Description errors in the Report on the seismic safety assessment of unit 1 and unit 7 of Kashiwazaki-kariwa Nuclear Power Station

第 7.2.2.4-20 図 炉内構造物水平方向
最大応答加速度 (NS 方向)

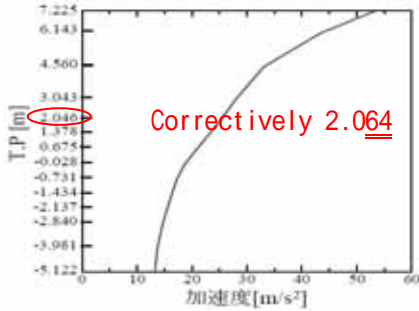
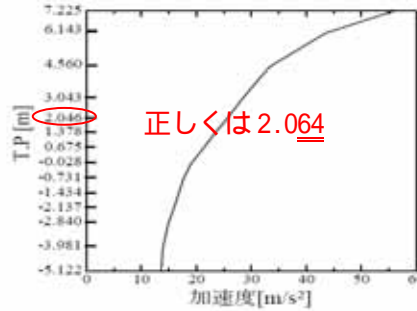
Figure in scale of axis was described “2.046” instead of “2.064”.
